# HIDEOUT, UTAH PLANNING COMMISSION REGULAR MEETING AND PUBLIC HEARING

## Staff Report

Re: Final Plat Recommendation for Lake View Estates

SITE DEVELOPMENT CONSTRUCTION PLANS, LAKEVIEW ESTATES, FINAL

**Originally Submitted Subdivision Layout (March 2020)**

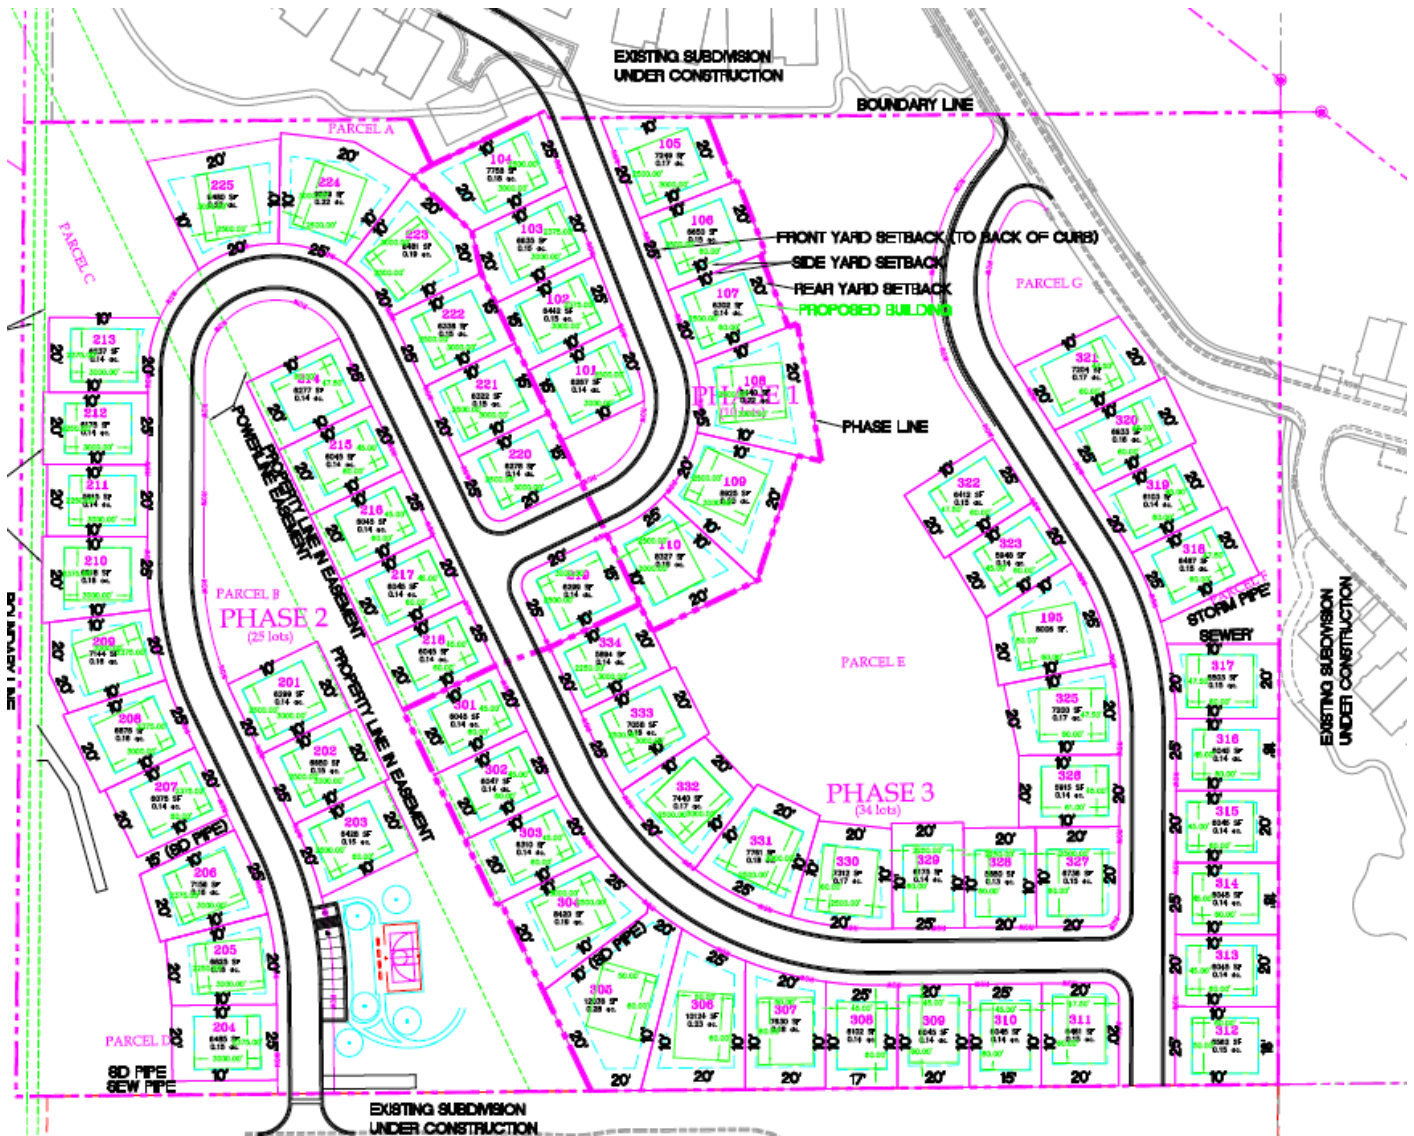
- **At a public hearing on April 9, 2020, the Town Council required:** reduced density, elimination of traffic hammerheads, vehicular connection to rights-of-way to the neighborhood to the south, increased open space continuity, a reduced number of retaining walls (with reduced heights), improved trail connectivity, and detention basin details among other requirements.

- The new layout increases open space connectivity, moves the park area into the proposed houses, connects the neighborhood to the Shoreline neighborhood, reduces the number and height of retaining walls. In addition, the new design has almost exclusively uphill and downhill lots, and no side slope lots (which are more challenging to build and more impactful to the landscape).

- The original plan included an average lot size = 70' x 98'
  - The new proposal includes +/- 65' wide x 100' deep lots
  - This equates to a building envelope of +/- 45'+ wide x 60' deep

- Prior to the revised design, the original approval at the Planning Commission approved a plan set with deed restrictions that required varied front setbacks of 30' (with some 25' setbacks)

- Lot 314 – 18' rear yard setback
    - Lot 316 – 18' rear yard setback
- The original plan indicated 10' side yard setbacks; this Final Plan adheres to those minimum required setbacks.

Additionally, the hammerheads have been removed from the plan. The Applicant must illustrate snow storage areas on site; these areas must be located outside of proposed Lot boundaries.

- What is proposed where the active open space (pickle ball courts) were originally located?
- How do residents in that area easily access this space? A stairwell should be considered in the location originally anticipated subdivision plan – between Lots 313 and 314 (as well as the newly proposed stairs between Lots 317 and 318).
- What is the proposed timing for the open space amenities?
- What is the extent of the dog wash? Is a building or canopy proposed?
- Trail typology (materials) must be included on the final set of plans. The trail under the powerlines, within the PUE, should be paved.

The Applicant confirmed the newly proposed subdivision plan reduced the number and size of the retaining walls. Based on the concept plan, the wall at the property line (service road) is about 10' high, the next one upslope is about 8' high, and the top two walls range from 6' to 10 high. The Applicant must include the exact locations of these walls and provide sections of all proposed retaining walls. Additionally, proposed wall type, materials, should be provided (stacked boulders were discussed in earlier meetings).

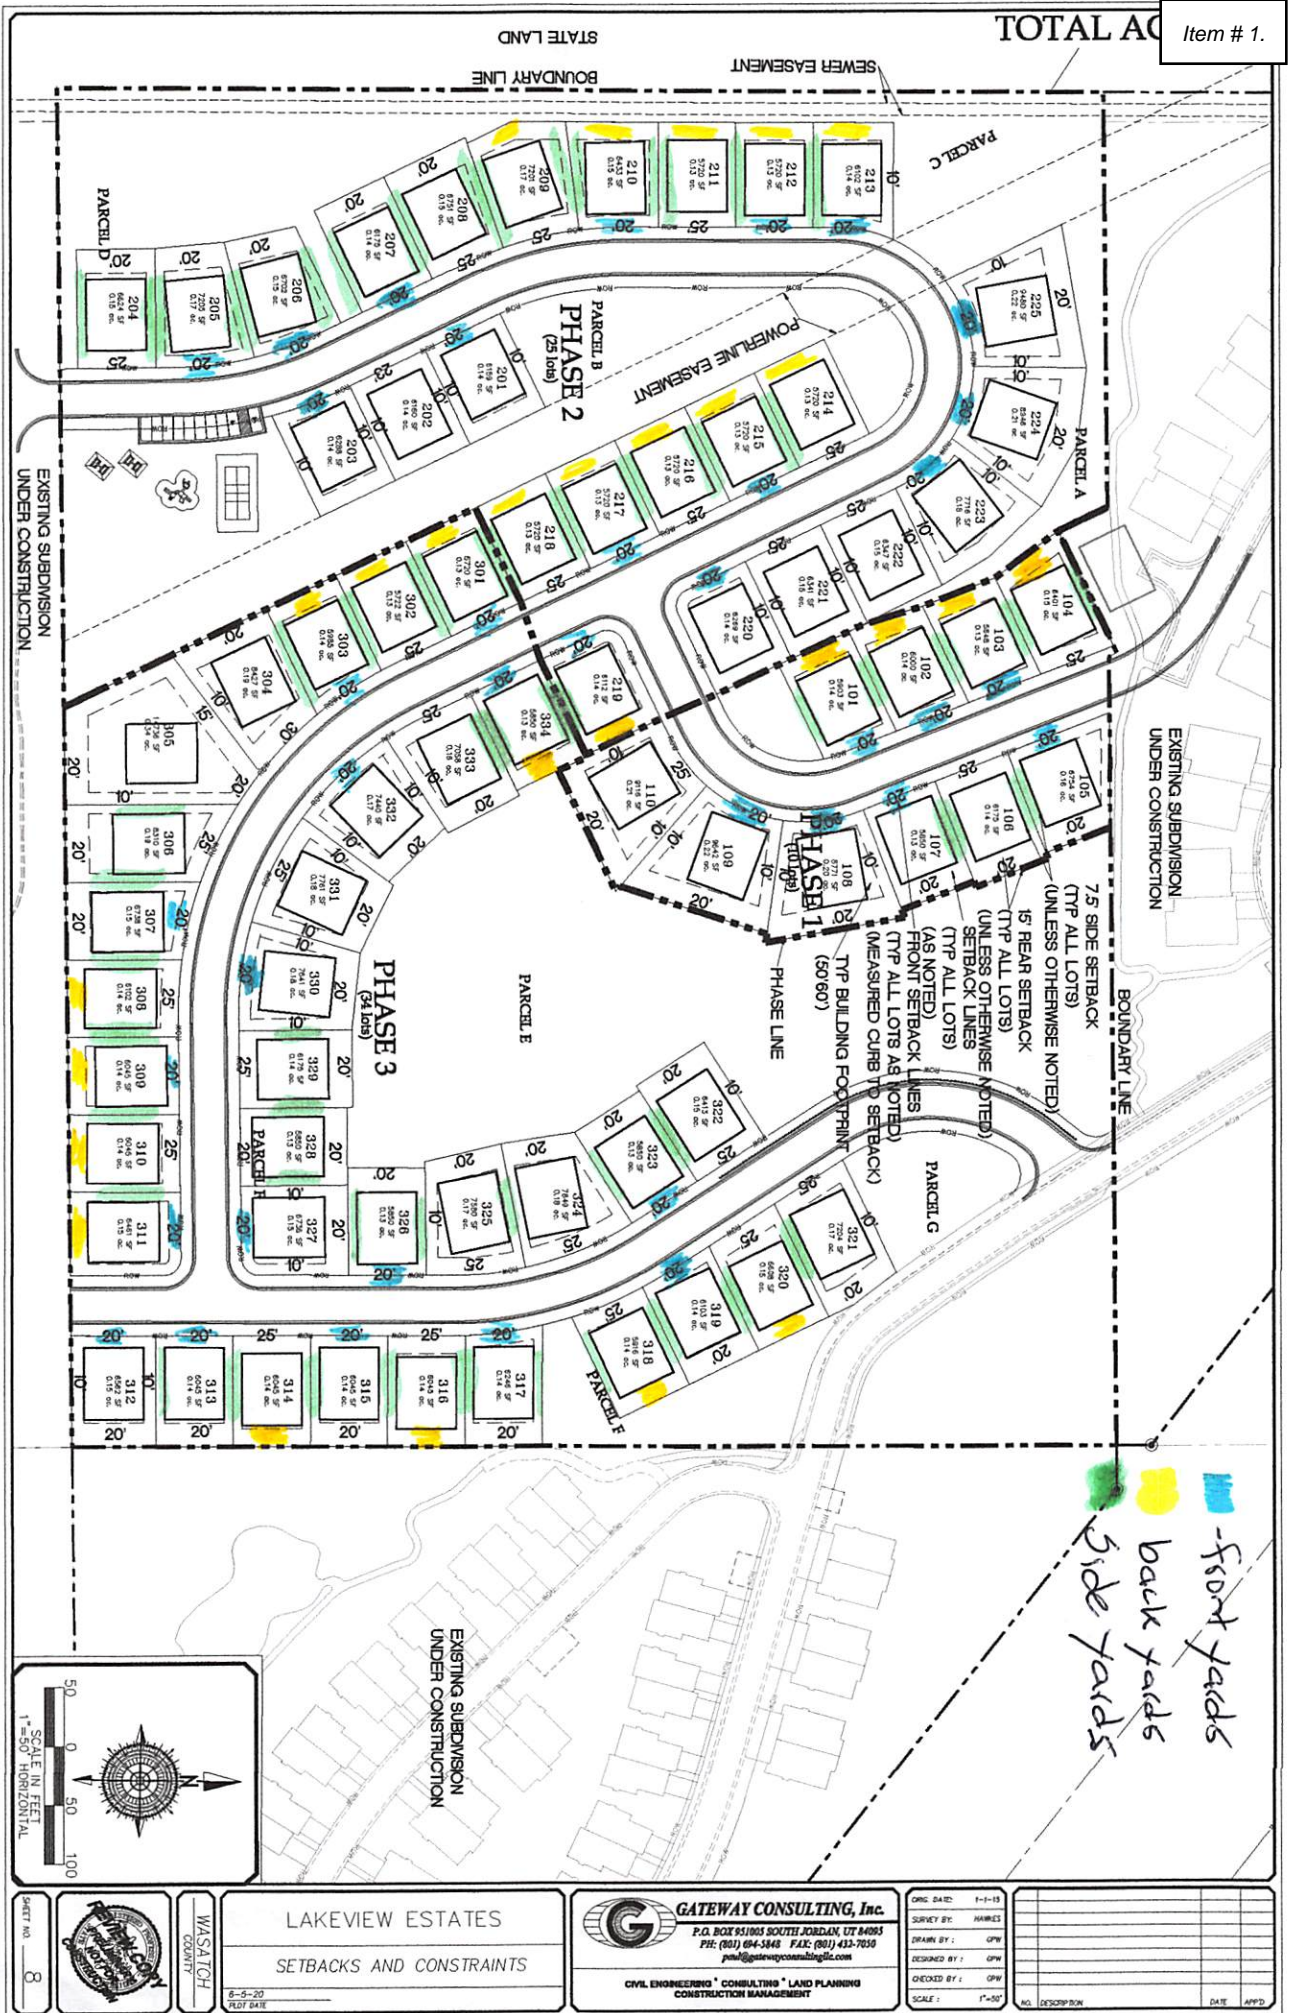
The proposed retention basin is in the same location as originally envisioned however it appears to occupy less area. The Applicant must address the following issues:

- No embankment shall be greater than a 3:1 slope and no rock or concrete material may be used in the storm water basin.
- The natural storm water basin shall be planted with native vegetation and this must be provided as part of an overall Landscape Plan (plant species, locations, sizes, etc.)
